UNITED STATES
DEPARTMENT OF THE INTERIOR
BUREAU OF LAND MANAGEMENT

SUNDRY NOTICES AND REPORTS ON WELLS
Do not use this form for proposals to drill or to re-enter an abandoned well. Use Form 3160-3 (APD) for such proposals.

8. Well Name and No. CASSIDY 18 FED COM/705H

EOG respectfully requests an amendment to our approved APD for this well to reflect the following changes:

Revised Wellbore

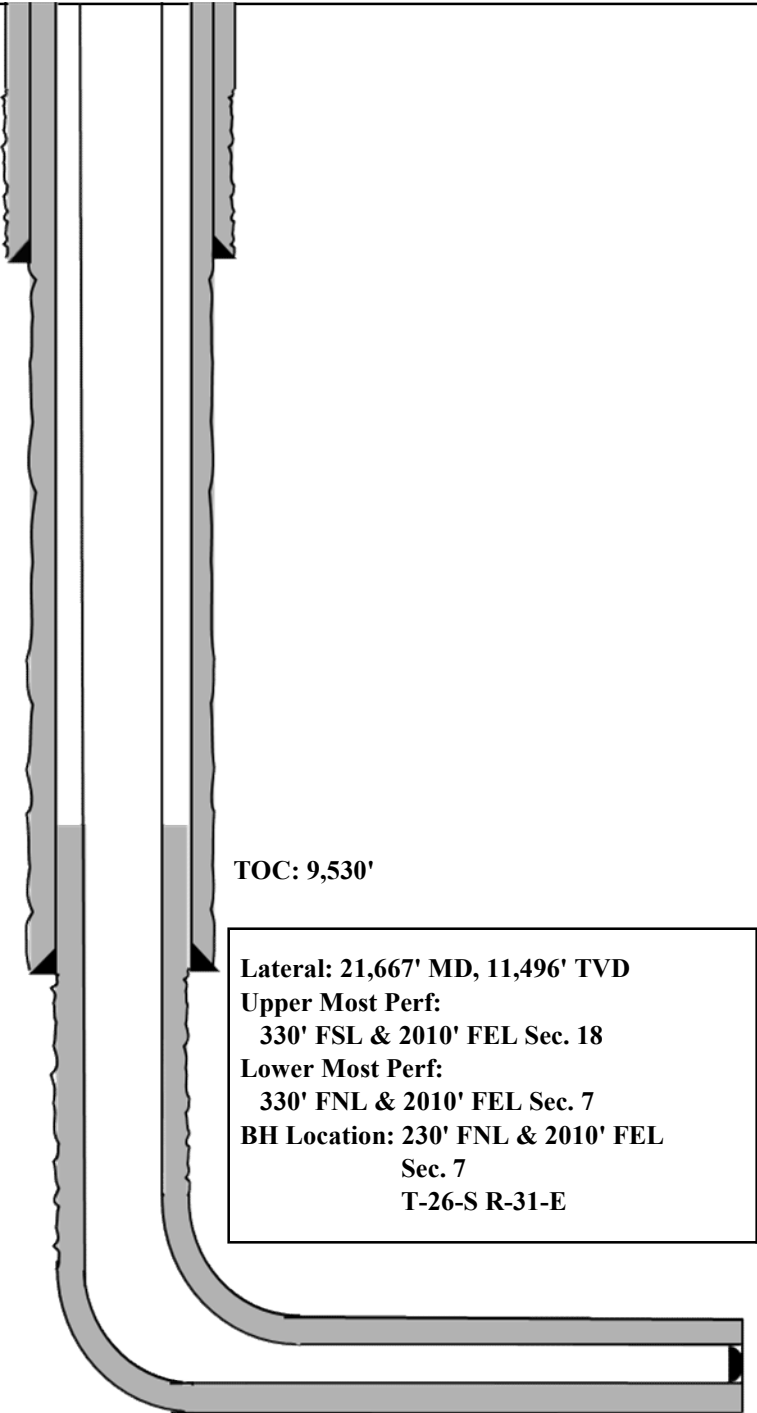
Update casing and cement program to current design.

Casing Design A

Bit Size: 12-1/4"
9-5/8", 36#, J-55, LTC,
@ 0' - 1,040'

Bit Size: 8-3/4"
7-5/8", 29.7#, HCP-110, FXL,
@ 0' - 10,030'

Bit Size: 6-3/4"
5-1/2", 20#, P110-EC, DWC/C IS MS,
@ 0' - 9,530'

5-1/2", 20#, P110-EC, Vam Sprint SF,
@ 9,530' - 10,030'

5-1/2", 20#, P110-EC, DWC/C IS MS,
@ 10,030' - 21,667'

Plan: Plan #0.2

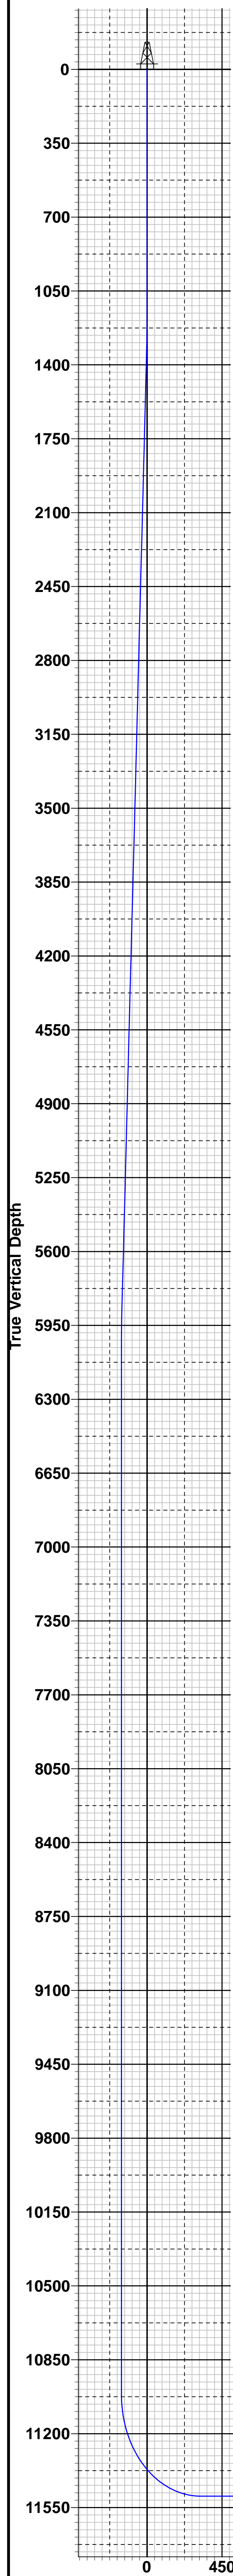
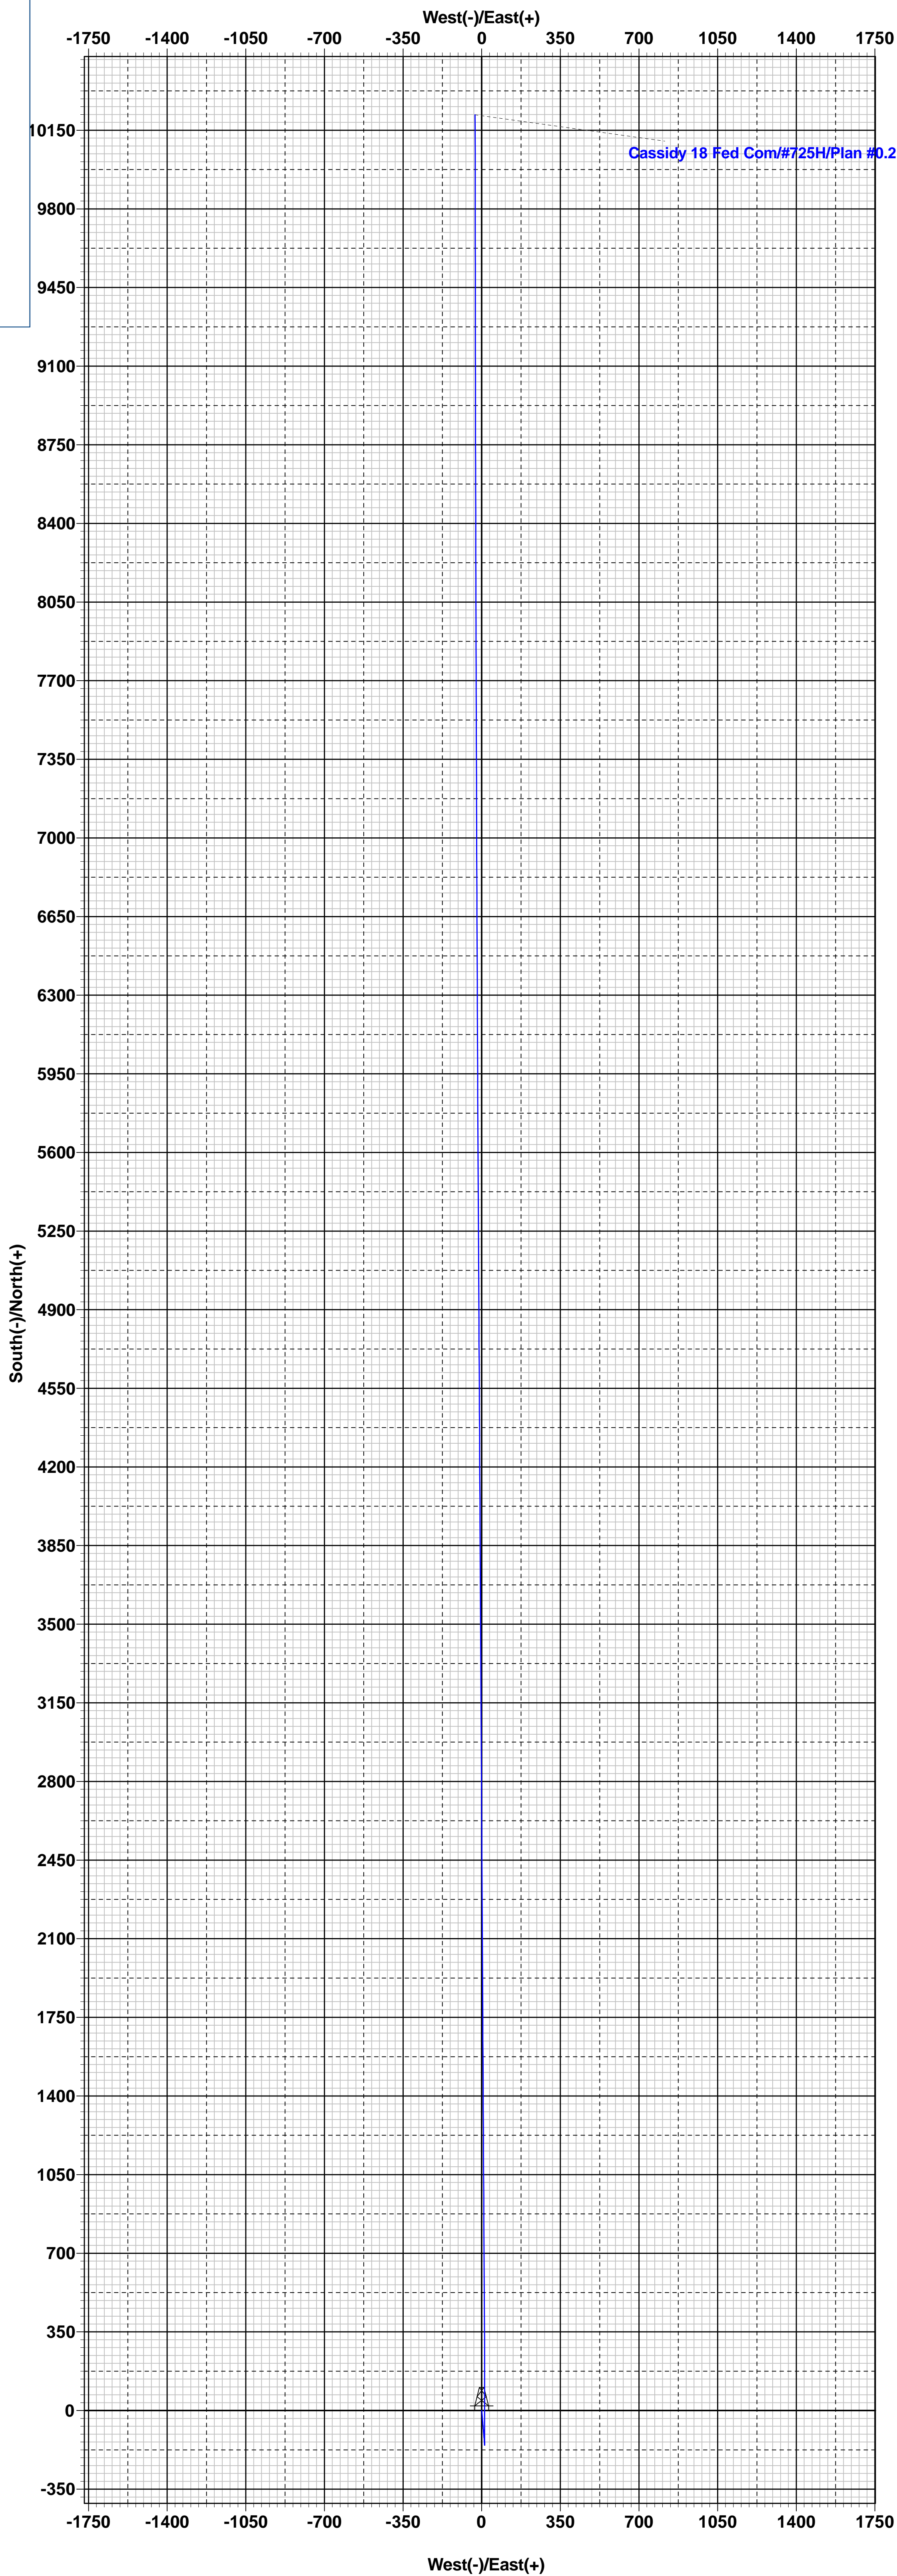
Change BHL from T-26-S, R-31-E, Sec 7, 230' FNL, 1650' FEL, Eddy Co., NM, to T-26-S, R-31-E, Sec 7, 230' FNL, 2010' FEL, Eddy Co., N.M.

BHL: 230' FNL & 2010' FEL, Section 7, T-26-S, R-31-E, Eddy Co., N.M.
